UNITED STATES PATENT AND TRADEMARK OFFICE

APPLICATION NO.	FILING DATE	FIRST NAMED INVENTOR	ATTORNEY DOCKET NO.	CONFIRMATION NO.
09/737,770	12/18/2000	In-Duk Song	8733.339.00	8950

Office Action Summary

DETAILED ACTION

FIG. 2E

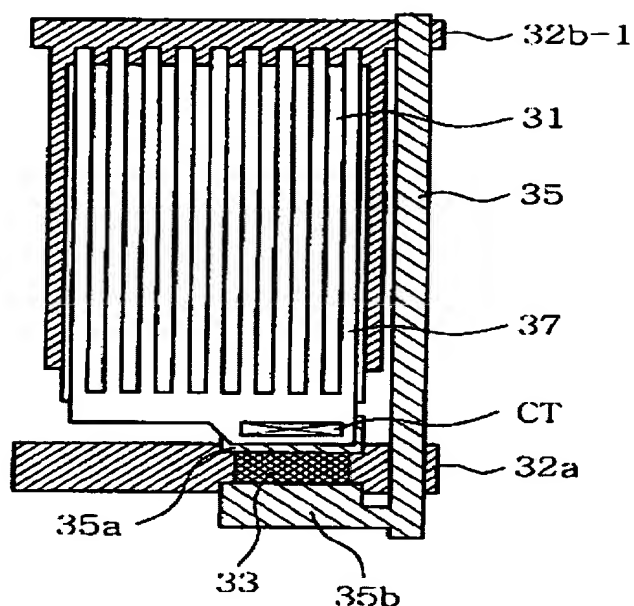
As to claims 1 and 2, 7, 10, Jeon discloses in Figures 2A-2E, an in-plane switching liquid crystal display (LCD) device comprising: a gate line, 32a, on a first substrate; a data line, 35, on the first substrate, the data line being perpendicular (as illustrated) to the gate line; a common line, 32b-1, on the first substrate, the common line being parallel (as illustrated) with the gate line and being formed of a metal (Cr for both gate line and common line; col. 2, lines 49-58, especially lines 55-58); a pixel electrode, 37, (ITO; col. 3, lines 18-22) and the common electrode, 31, (ITO; col. 2, lines 64-67) being formed of a transparent conductive material (ITO); and a liquid crystal layer between the first and second substrates (inherent to comprising a LCD device).

As to claims 4, 5, and 11, Jeon discloses the device of claim 1, further comprising a first ITO layer (Figures 2A-2C and col. 2, lines 49-52) (Applicant's auxiliary common line) on the first substrate (col. 2, lines 49-67, especially lines 55-58), the auxiliary common line being connected with the common electrode, 31, on the same layer as the gate electrode (formed during same process steps, col. 2, lines 55-58). The first ITO layer of Jeon exists everywhere under the first metal layer of Jeon, forming Applicant's auxiliary lines, it is the same ITO layer that forms the common electrode, and the portion of the ITO layer that is under the common line is connected to the portion of the ITO layer that serves as the common electrode.

As to claim 17, Jeon discloses in Figures 2A-2E, in-plane switching Liquid Crystal Display (LCD) device, comprising: a first substrate and a second substrate a gate line, 32a, on the first substrate; a metal common line, 32b, (Cr for both gate line and common line; col. 2, lines 49-58) on the first substrate, the common line parallel (as illustrated) to the gate line, a data line, 35, on the first substrate, the data line being perpendicular (as illustrated) to the gate line; a common electrode, 31, on the first substrate; a thin film transistor having a gate electrode, a source electrode, 35a, and a drain electrode, 35b, formed on the first substrate; liquid crystal interposed between the first and second substrates (inherent to comprising a LCD device); a pixel electrode, 37, contacting the source electrode (Applicant's drain electrode) of the thin film transistor; and wherein, the pixel and common electrodes are formed of a transparent conductive material (ITO; col. 3, lines 18-22, and col. 2, lines 64-67).

As to claim 18, Jeon discloses the LCD device of claim 17, wherein a portion of the common line overlies a portion of the common electrode (Figures 2A-2E, especially Figure 2C, and col. 2, lines 49-67, especially lines 64-67).

FIG. 3

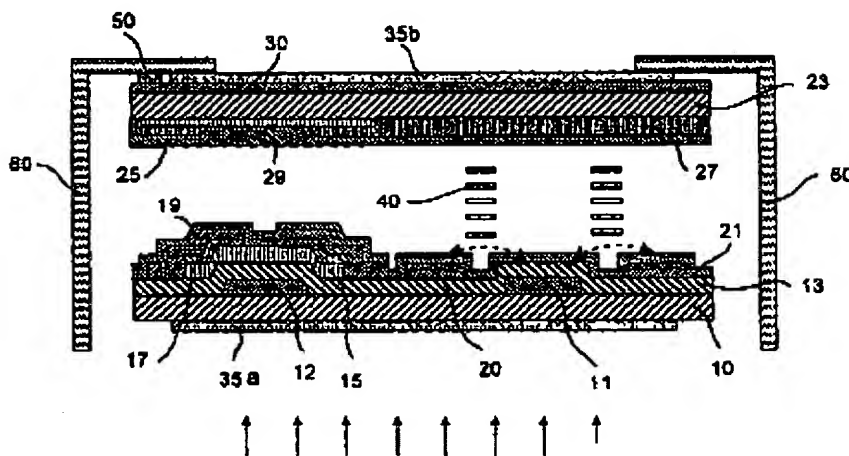
Son teaches in Figure 3, an LCD device, further comprising a light-shielding layer, 25, (Applicant's black matrix) on the second substrate, 23, (para 0029).

Son is evidence that ordinary workers in the art of liquid crystals would find the reason, suggestion, or motivation to use a black matrix on the second substrate to prevent light from leaking around the TFT (first two lines of para 0029).

FIG. 1

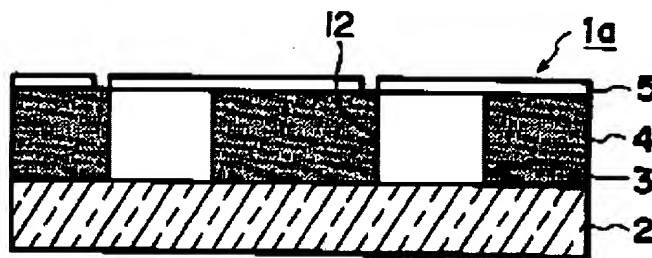
Ishikura teaches in Figure 1 (col. 3, lines 34-54) a device wherein a portion of the transparent electrode, 5, (Applicant's common electrode) overlies a portion of the principle electroconductive layer, 12, (Applicant's common line), to improve conductivity and reduce resulting voltage waveform deformation (or distortion) (col. 1, lines 14-39).

Ishikura teaches in Figure 1 (col. 3, lines 34-54) a device wherein a portion of the ITO transparent electrode, 5, (Applicant's common electrode) overlies a portion of the principle electroconductive layer, 12, (Applicant's common line), to improve conductivity and reduce resulting voltage waveform deformation (or distortion) (col. 1, lines 14-39).

Ishikura teaches in Figure 1 (col. 3, lines 34-54) a device wherein a portion of the ITO transparent electrode, 5, (Applicant's auxiliary gate line and auxiliary gate pad) overlies a portion of the principle electroconductive layer, 12, (Applicant's gate line and gate pad), to improve conductivity and reduce resulting voltage waveform deformation (or distortion) (col. 1, lines 14-39).

FIG.1
(PRIOR ART)

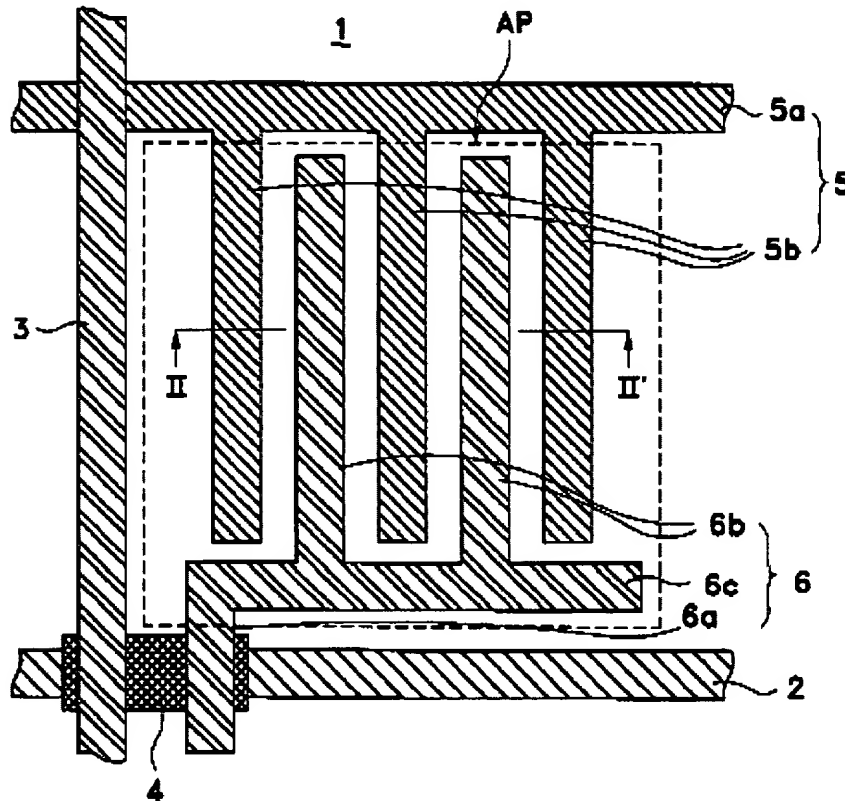
Shin teaches as prior art in Figures 1 and 2 the use of a pixel electrode, 6b, formed of an opaque metal (col. 2, lines 3-6) in order to block a light of the area in which the liquid crystal molecules are not operated in an in-plane switched LCD.

Shin is evidence that ordinary workers in the art of liquid crystals would find the reason, suggestion, or motivation to add opaque metal electrodes in order to block a light of the area in which the liquid crystal molecules are not operated.
